I have some questions about CSR for bulk carrier in Chapter 4 section 6 Internal Pressures and Forces

Question 1

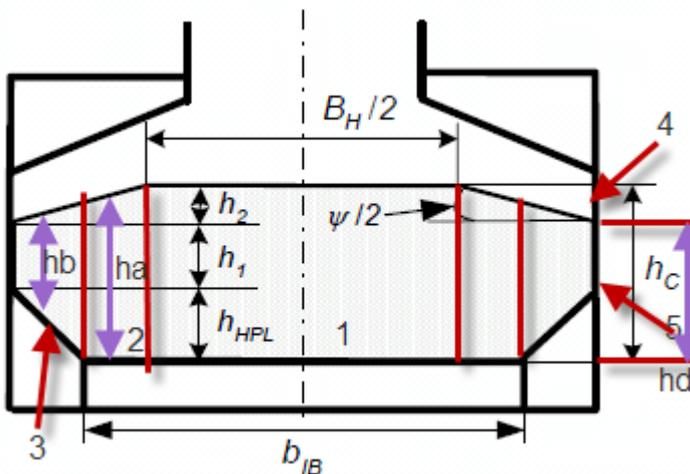
For loading condition where the cargo hold is not loaded to the upper deck (Chapter 4, Section 6, 1.1.2)

As shown in the figure above,

a. Whether the cargo pressures in the still water for inner bottom region 1 and 2 are the same or not since it seems that the cargo heights are different for these two areas? If not, the cargo pressure for inner bottom 2 should be $p_{CS} = \rho_C g K_C (h_a + h_{DB} - z)$ or not?

b. Whether the P_{CS} for the side area 4 is zero although this area is below h_c ?

c. When calculating the still cargo pressures on the hopper tank plate, should I use

$$p_{CS} = \rho_C g K_C (h_c + h_{DB} - z) \text{ OR } p_{CS} = \rho_C g K_C (h_b + h_{DB} - z)$$

d. For the cargo pressures on the side, should I use h_d instead of h_c ?

Question 2

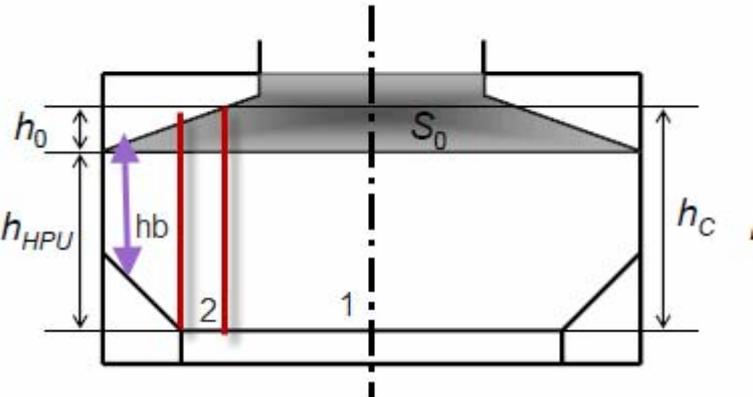
For loading condition where the cargo hold is loaded to the upper deck (Chapter 4, Section 6, 1.1.1)

- a. In this case, what is the value of ψ ? 0° or the angel between top side tank plate and the horizontal plane?
- b. Whether the cargo pressures in the still water for the inner bottom region 1 and 2 are the same or not?
- c. For the hopper tank plate, should I use hb instead of hc ?
